CHANGES AND ADDITIONS TO
BULLETIN 1108B, ISSUE 2
BULLETIN 1126B, ISSUE 2
PARTS - MODEL 14 REPERFORATOR TRANSMITTER

Bulletin 1108B, Page 20
Bulletin 1126B, Page 19

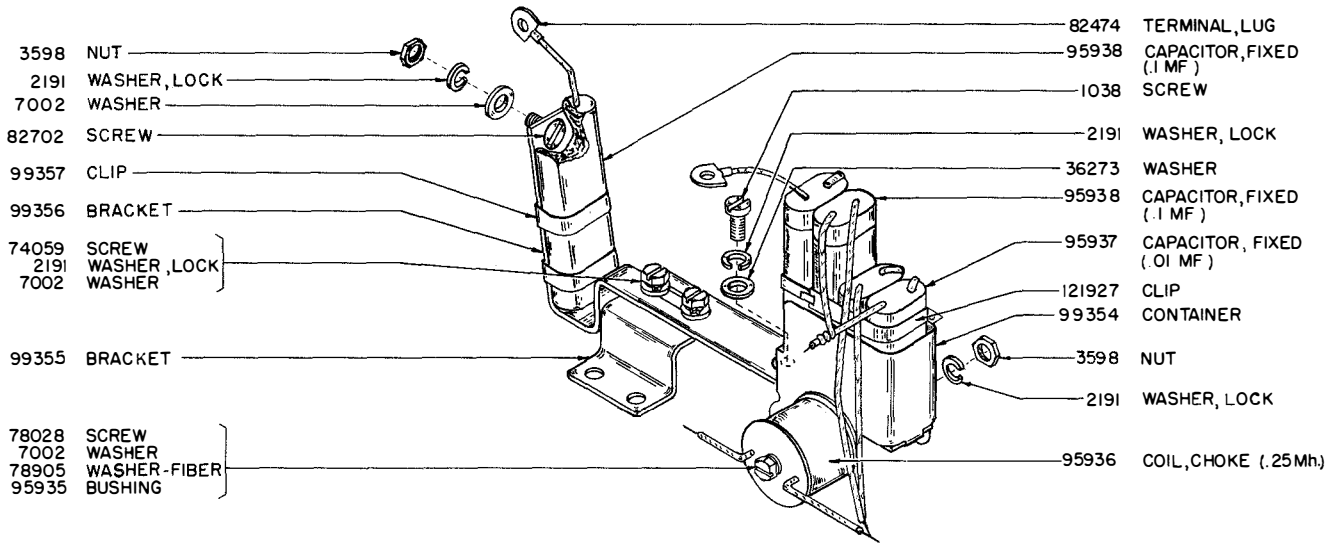
The 102450 selector levers have been replaced by 135011 selector levers.

FIGURE I

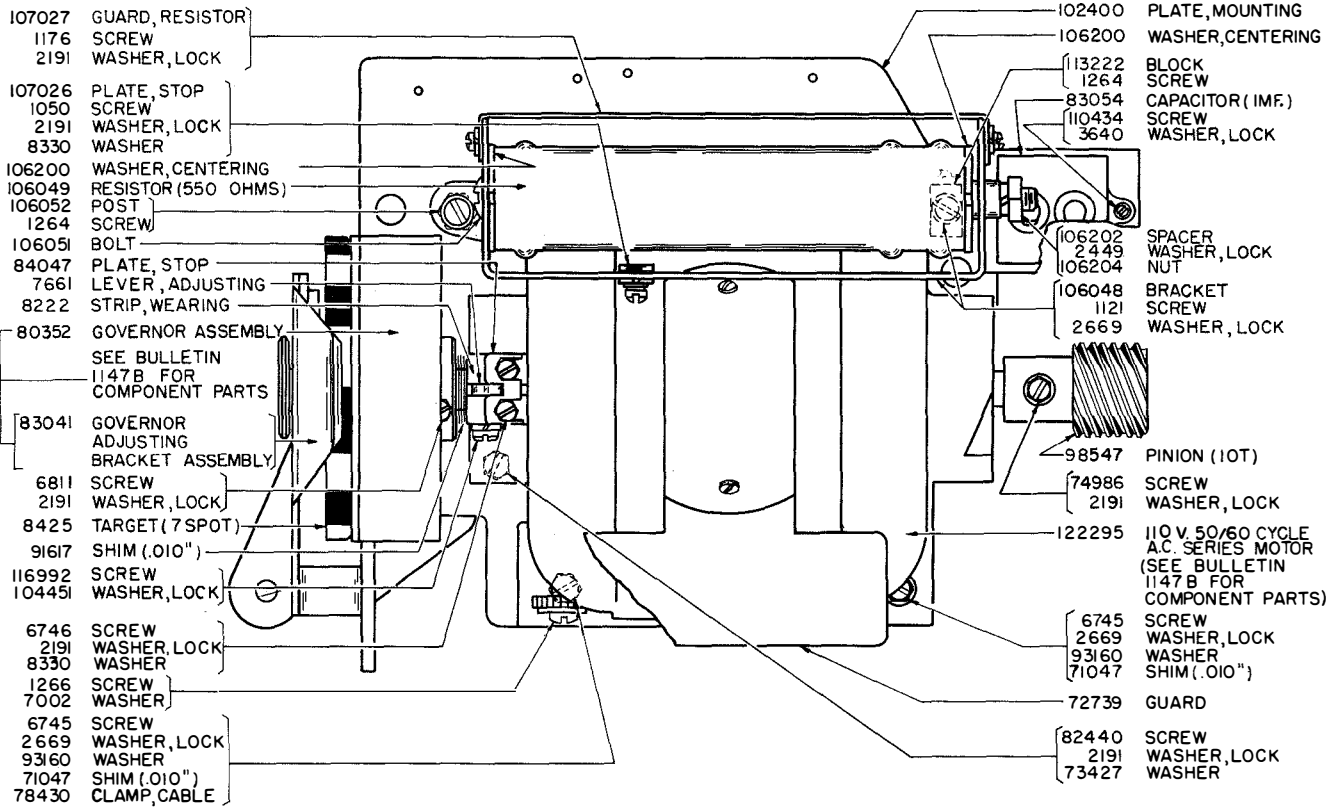
The 135687 governed motor arrangement with gears for receiving at 404 opm and sending at 368 opm is illustrated in Figure 1 of this correction sheet.

135687 A.C. GOVERNED MOTOR ARRANGEMENT
(WITH GEARS FOR 404 O.P.M. RECEIVING AND 368 O.P.M. SENDING)

FIGURE 2

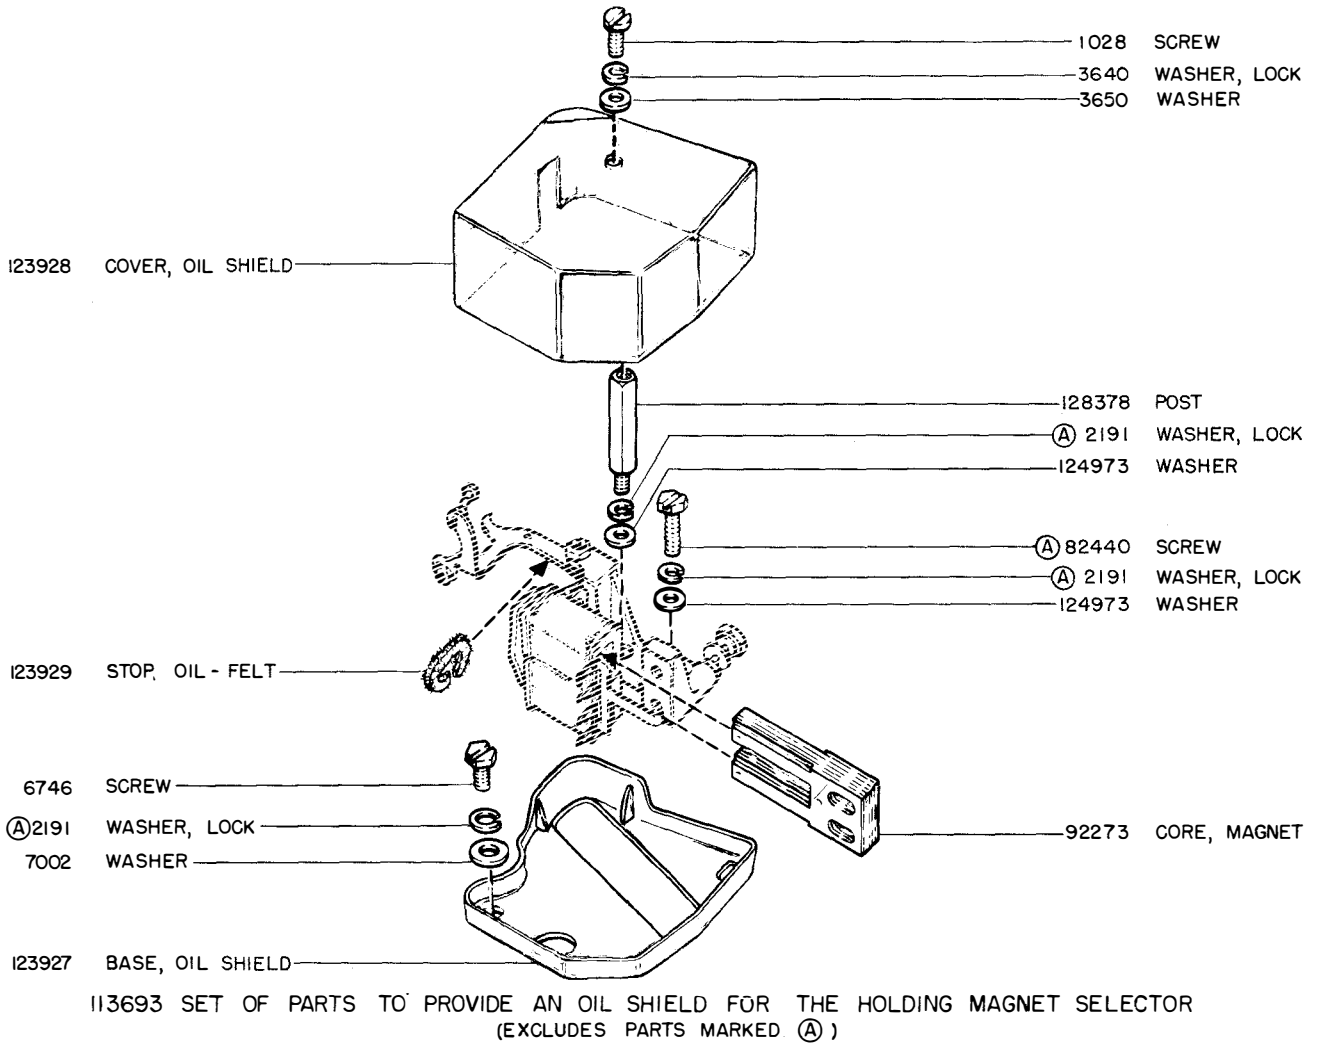
See Figure 2 for the revised illustration of the 113693 set of parts to provide an oil shield for the holding magnet selector.
